# **ASSESSMENT REPORT 54**

## **McArthur River Mine Open Cut Project**

### **ENVIRONMENTAL ASSESSMENT REPORT**

**Environment Protection Agency (EPA) Program**

Figure 1 Valley bottom extent indicating alluvial landforms

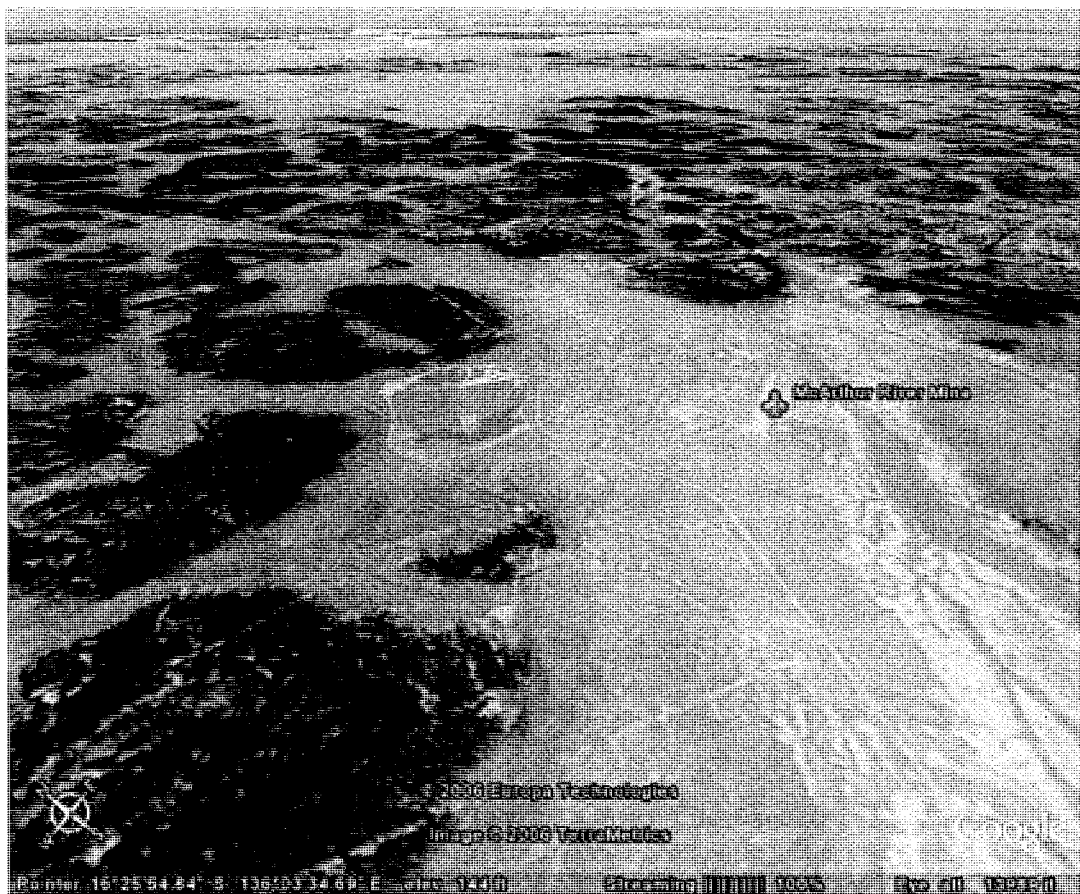
The risk analysis based on the 1:500 year flood event indicated that the TSF would be in the potential flood impact area. We checked this using a terrain analysis index MrVBF (Gallant and Dowling (2003) which is interpreted as an index of deposition, based on the assumption that flat valley bottoms are flat because they are filled with sediment. The index separates upland terrain dominated by erosional processes from lowland depositional terrain. The MrVBF index is available from the ASRIS web site (). This indicates the extent of alluvial landforms and associated drainage systems in low relief terrain at the site (Figure 1).

Figure 1, combined with the flood risk analysis in the PER identifies the TSF footprint with a flood plain environment. Consequently, the risk setting used for design of the embankment appears to be appropriate.

**Figure 6.** Bank erosion, pool scour and flood chute development on Surprise Creek. (W.D. Erskine photographs).

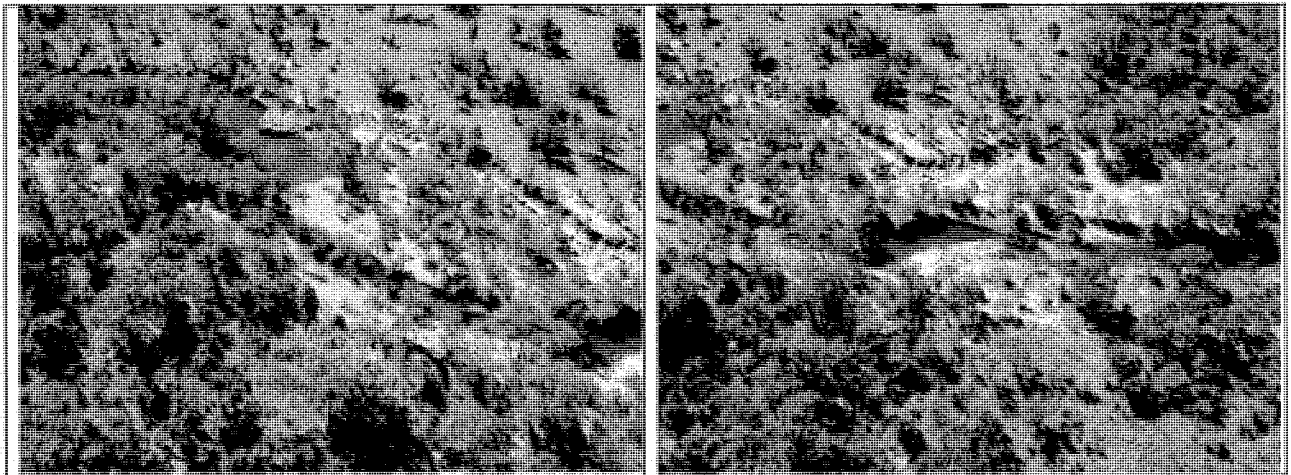
Erskine (2006) noted that little design information on the Barney Creek diversion channel was included in the Draft EIS (URS, 2005a) and that no hydrological data were presented. Furthermore, he also concluded that the fluvial geomorphology and aquatic habitats of Barney and Surprise creeks were not addressed in the Draft EIS (URS, 2005a) and so the diversion channel design could not be assessed as to how well it mimicked the natural channel.

The design of the Barney Creek diversion channel has been modified since the Draft EIS and its Supplement (URS, 2005a; 2005b). The fluvial geomorphology and aquatic habitats of Barney and Surprise creeks are discussed in Sections 5.3 and 5.4, respectively of the Public Environmental Report (URS, 2006). Significantly, field inspections have established that the lower section of Barney Creek is often backwater-affected by the McArthur River, as evidenced by its channel morphology and the perched nature of the channel bed of Barney Creek above the main stream. Furthermore, there are many bedrock outcrops in the channel and gravel lag deposits. Nevertheless, there are extensive areas of bank erosion, pool scour and flood chute development on Surprise Creek (Figure 6). These indicate that Surprise Creek is not as stable as Barney Creek and responds to floods.
